**RE: AIS – Indian Pueblo Center
1120 Indian School NW
Grading and Drainage Plan Stamp Date: 12/16/19
Hydrology File: H13D009**

**RE: AIS- INDIAN PUEBLO CENTER
1120 INDIAN SCHOOL NW
GRADING AND DRAINAGE PLAN STAMP DATE: 9/6/19
HYDROLOGY FILE: H13D009**

GRADING AND DRAINAGE
PLAN

SHEET #
GR-1

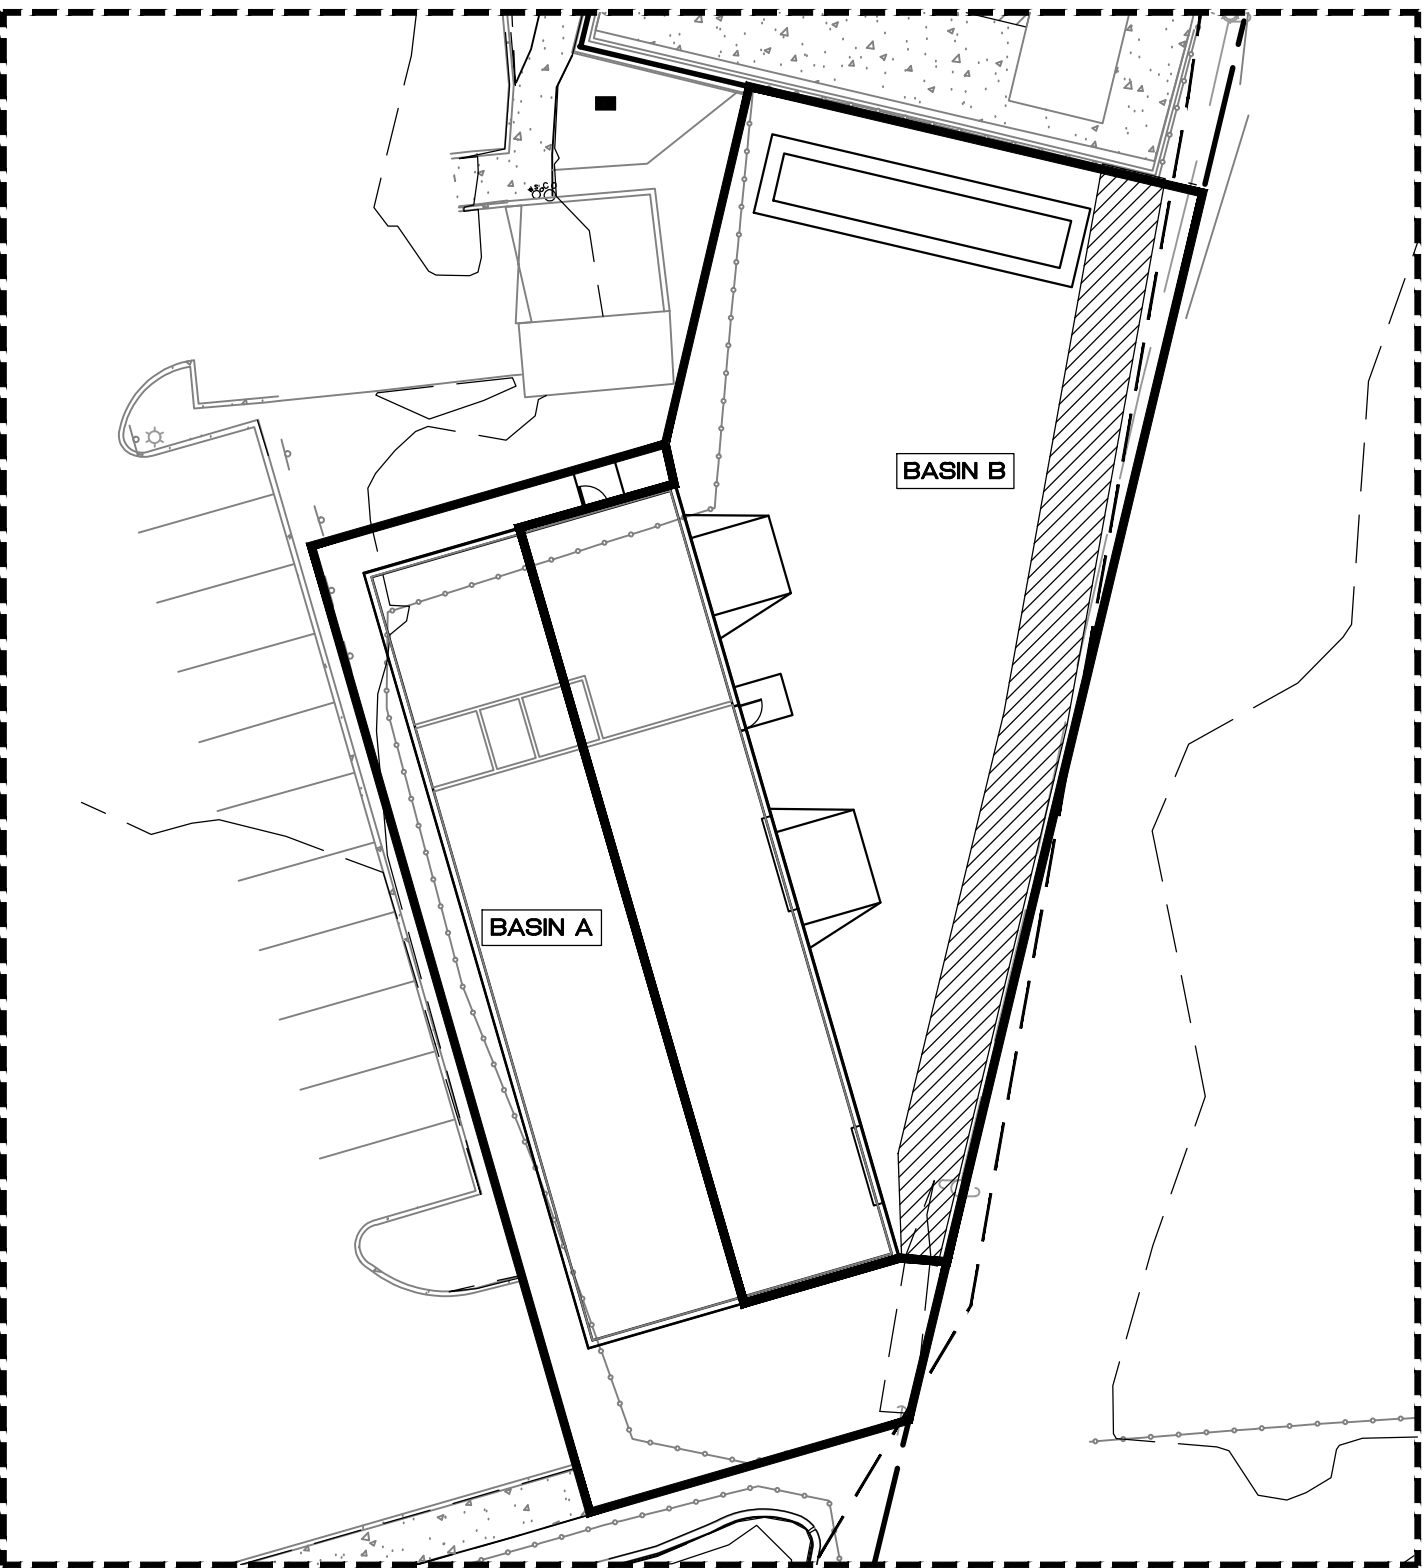
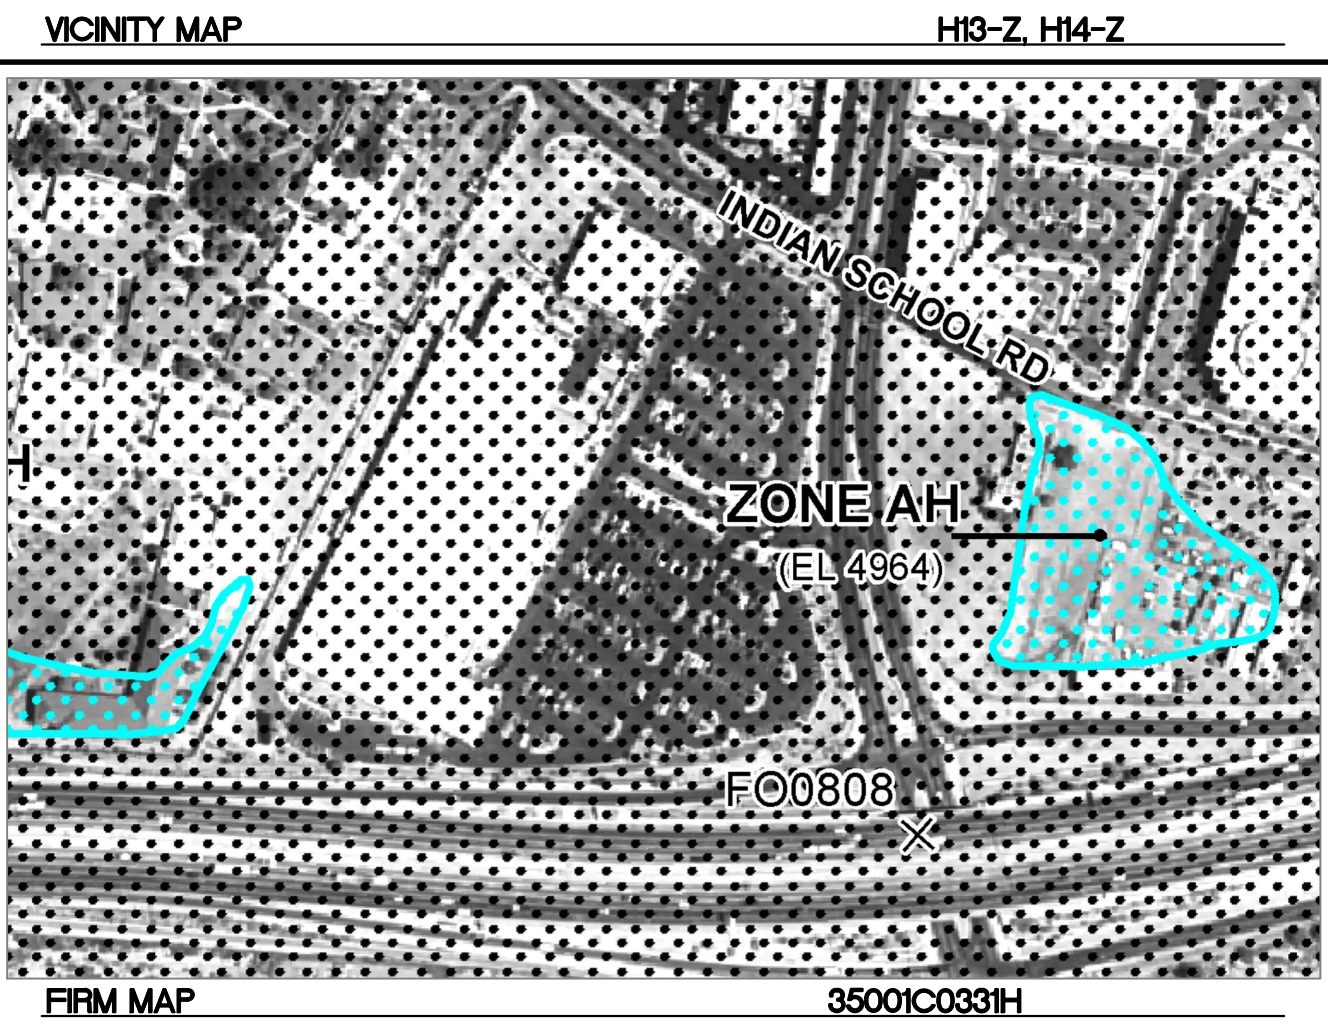
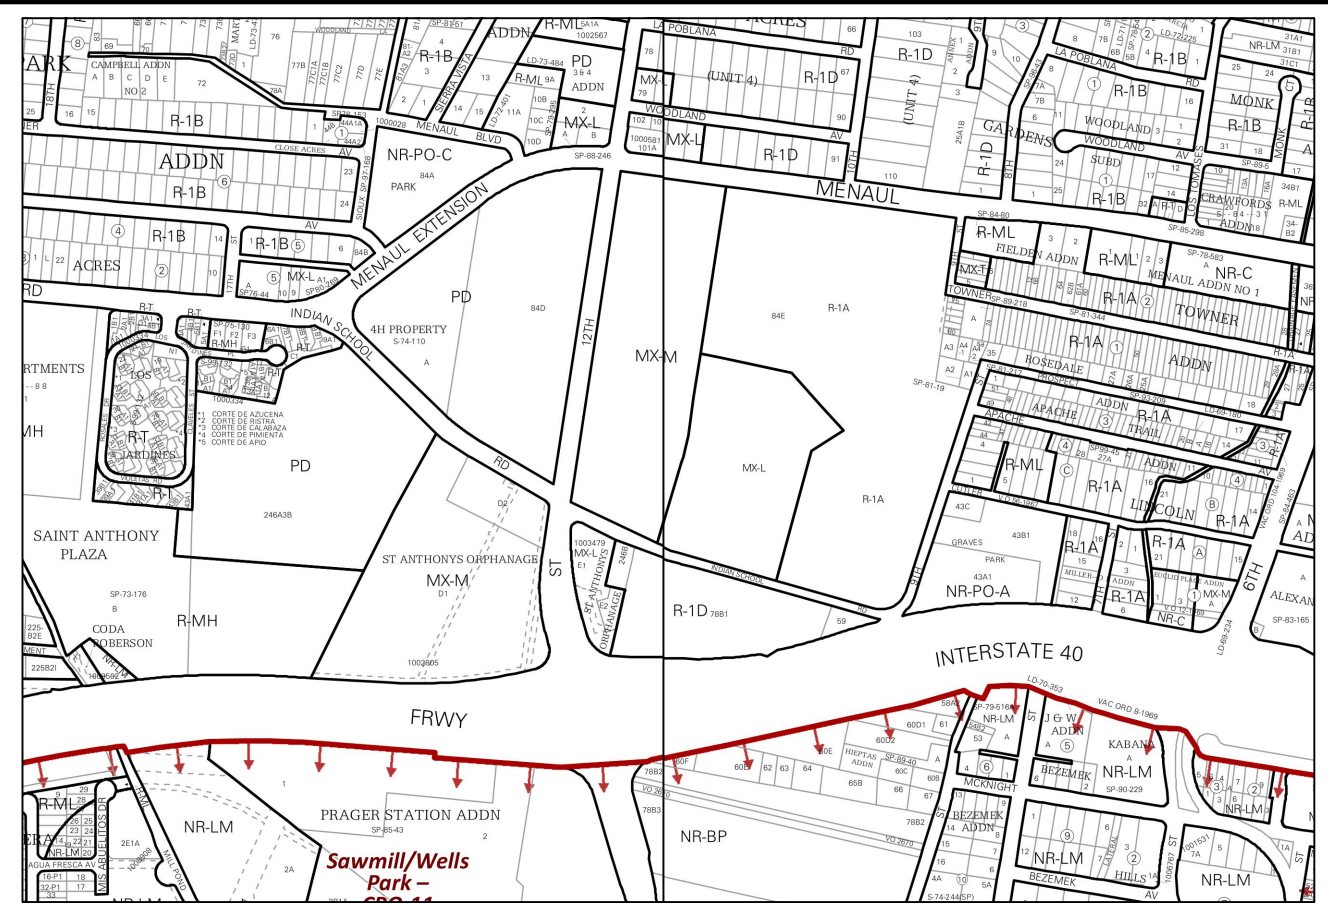
1. Show the extents of the floodplain on the grading plan; ensure the building finished floor is elevated at least 1' above the BFE.

2. A portion of this project is located in a floodplain (AH) and a floodplain development permit must be obtained. The permit application and grading plan must demonstrate zero rise to the base flood elevation, unless a Letter of Map Revision (LOMR) is being prepared. Please contact Rudy Rael, CFM for more information regarding floodplain development permits (rrael@cabq.gov or 924-3977).

3. Provide pond sizing and volume calculations for the new pond.

The extents of the mapped flood plain are shown on the Grading Plan and the limits are along the eastern property line of this parcel. The building elevation was set to one foot above the BFE although the flood plain does not affect the building footprint.

The proposed improvements do not affect the proposed flood plain. As shown on the Grading Plan the boundary of the flood plain is contained on the parcel to the east and is not affected by this project. As a precaution, a landscape berm is shown along the eastern property line to insure the flood plain does not affect this parcel.

This depressed area is a water harvesting area as opposed to a pond. The pond volume for this parcel is already accounted for in the existing pond located to the southwest of this parcel as shown on the approved overall drainage plan previously submitted.
